Tsunami Modeling Concerns for the Washington State Building Code Council to Consider

**Washington Geological Survey
and the State Emergency
Management Division**

5 Concerns with ASCE tsunami modeling of the Tsunami Design Zone (TDZ)

Comparison of **state tsunami modeling** vs. **ASCE tsunami design zone modeling** in Bow-Edison, WA

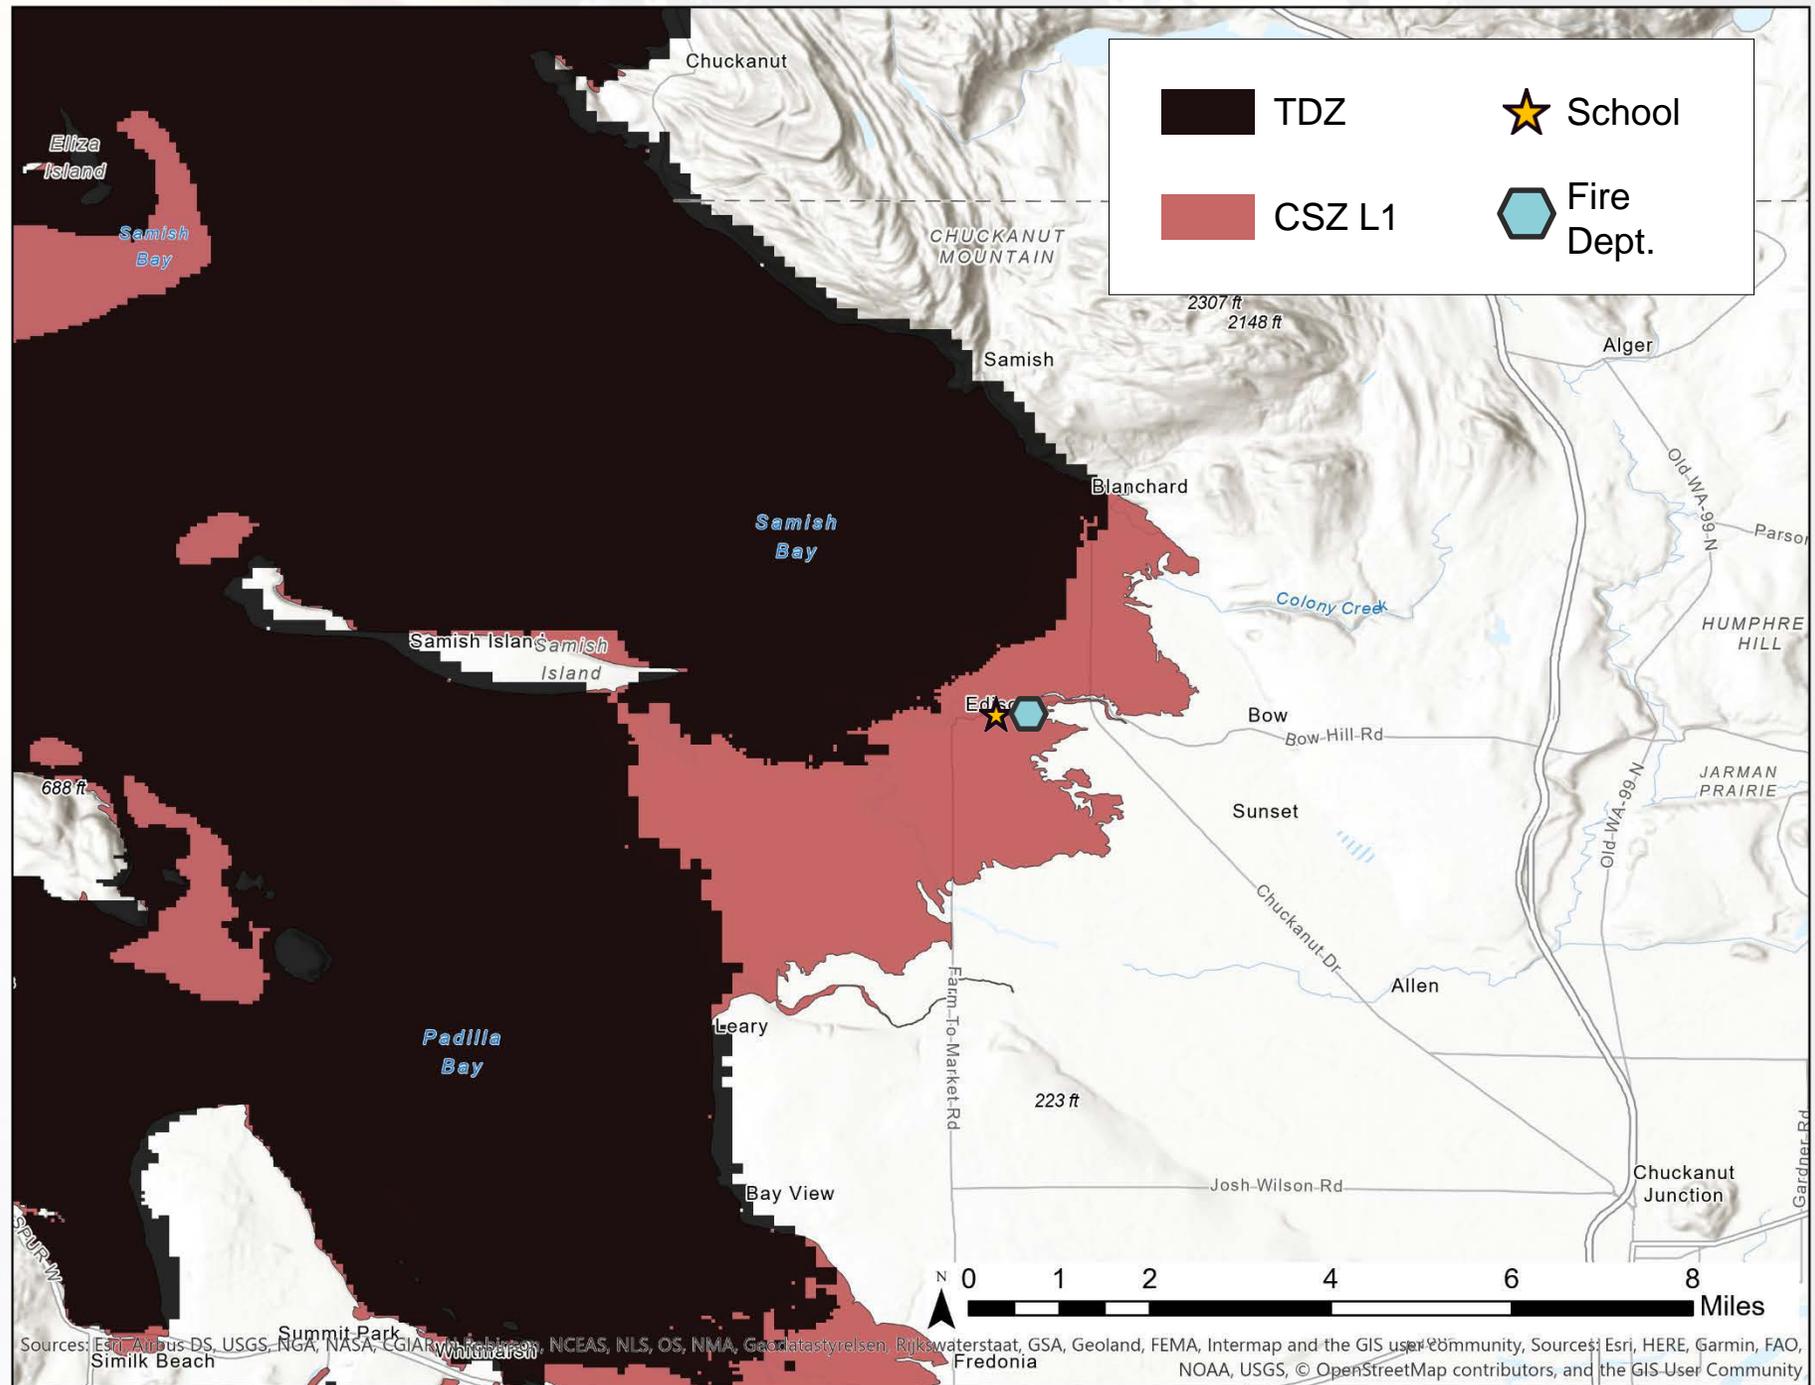
1. The tsunami modeling process used to develop the TDZ went through scientific review. **However, consensus on the tsunami source characterization is still needed, and the process was not well documented, publicly available, or reproducible.**
2. The TDZ is largely acceptable in terms of extent. **However, there are some significant discrepancies between extent, flow depth, and the 100-m bathymetry line in the TDZ, and in the published Cascadia data. These differences could lead to under-designed structures and/or the construction of critical facilities in unmapped tsunami hazard zones.** Until discrepancies in the sources can be better understood, Washington could adopt a more conservative approach for design and construction of critical facilities.

3. The **resolution of TDZ modeling is very poor (~60 m onshore)**, whereas **Oregon, California, and Washington tsunami modeling is done at no greater than 10 m resolution**. This is critical for capturing topography onshore and bathymetry offshore which both have a significant impact on tsunami inundation and run-up.

Tsunami Flow Depths on Tokeland Peninsula

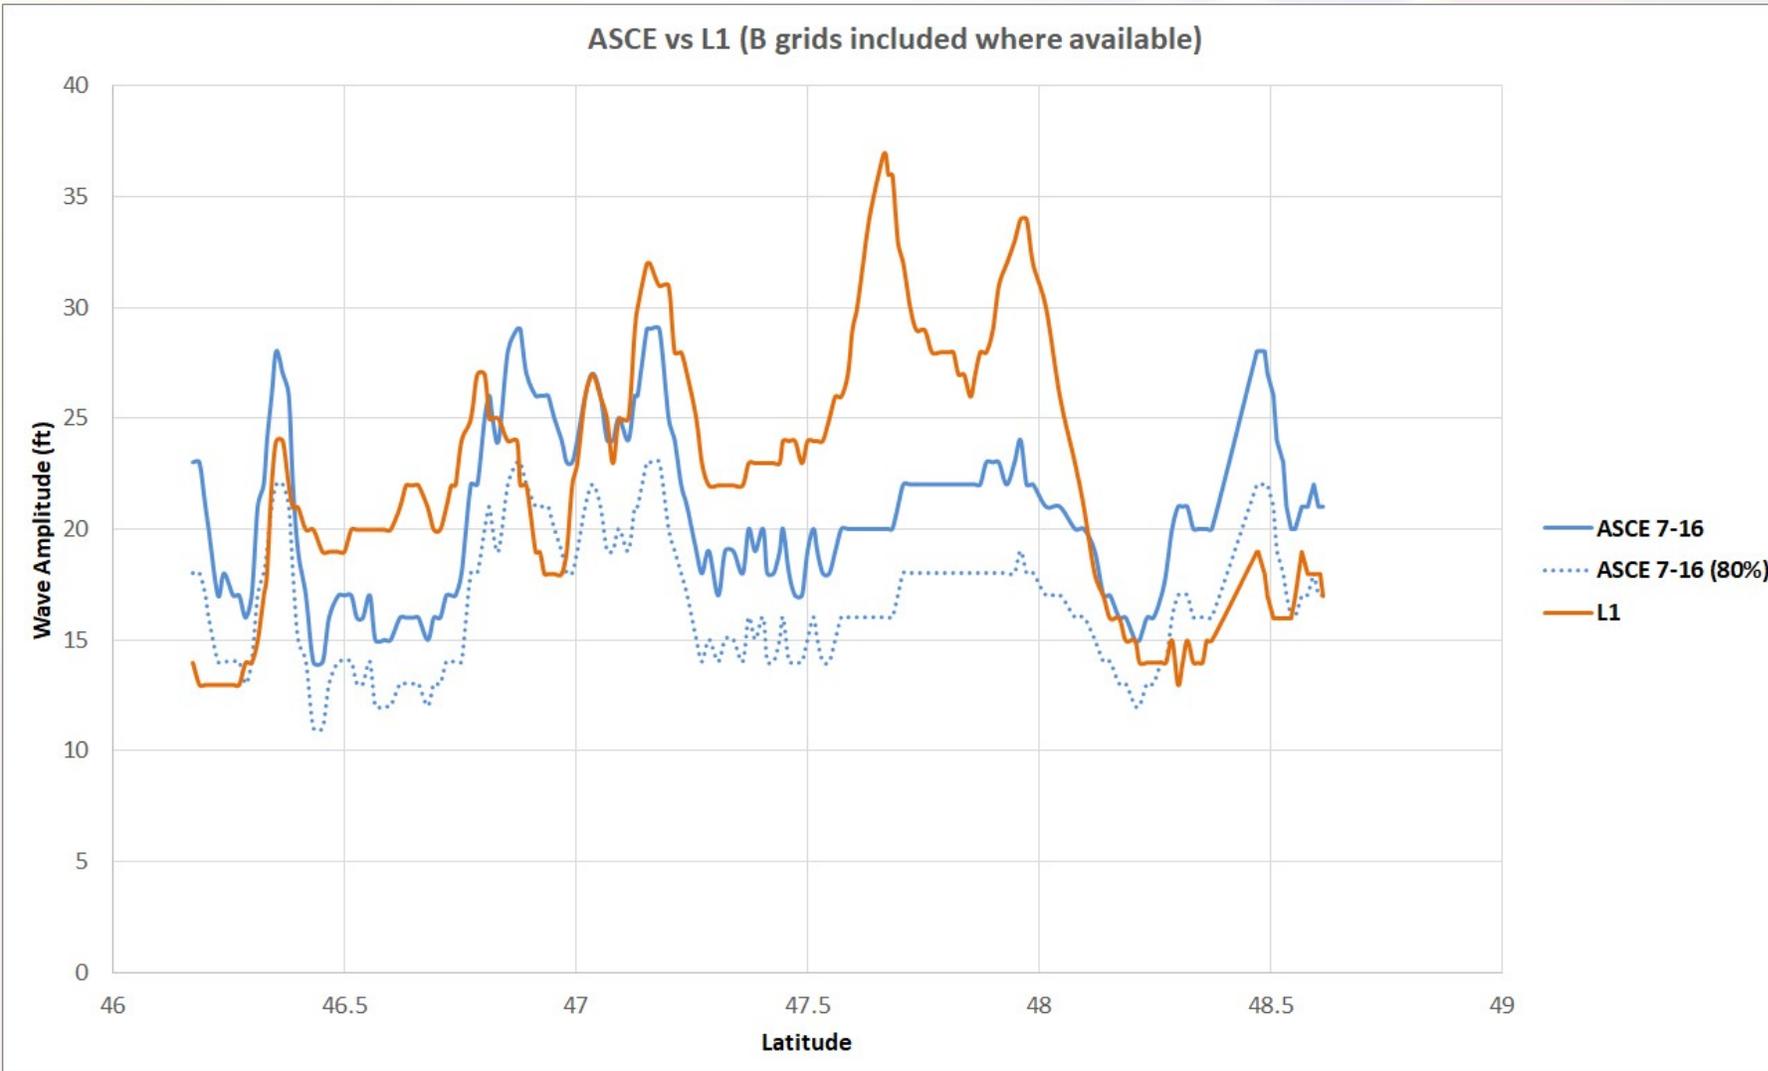
Onshore WA tsunami modeling is more conservative – Tokeland WA

Washington CSZ modeling compared to ASCE tsunami code requirements offshore

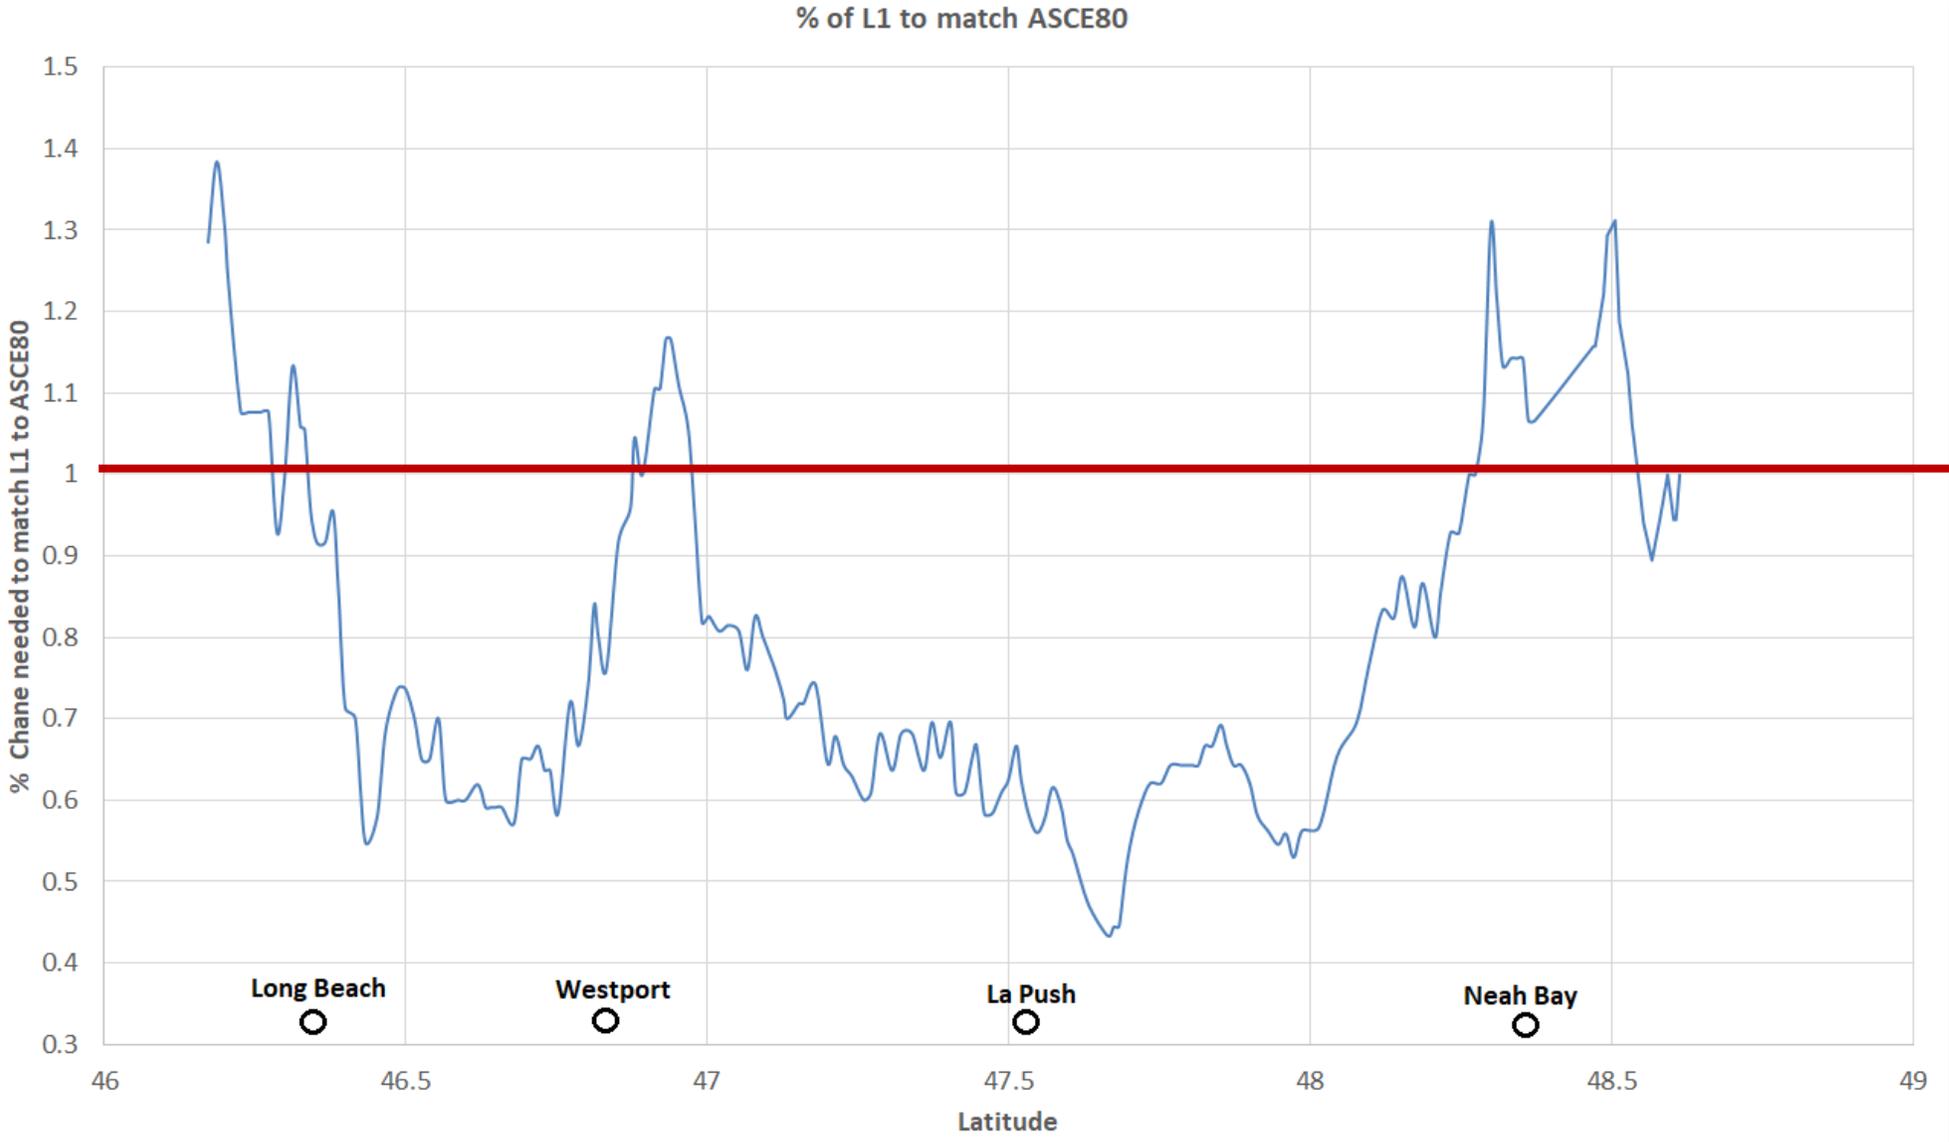
It is important to point out that most of **WA tsunami modeling** along the outer coast is “compliant” and **MORE CONSERVATIVE** than **ASCE requirements at the 100 m bathymetry line**. However, there are significant exceptions.

This is largely due to the low-resolution data used and likely from unrealistic source models.
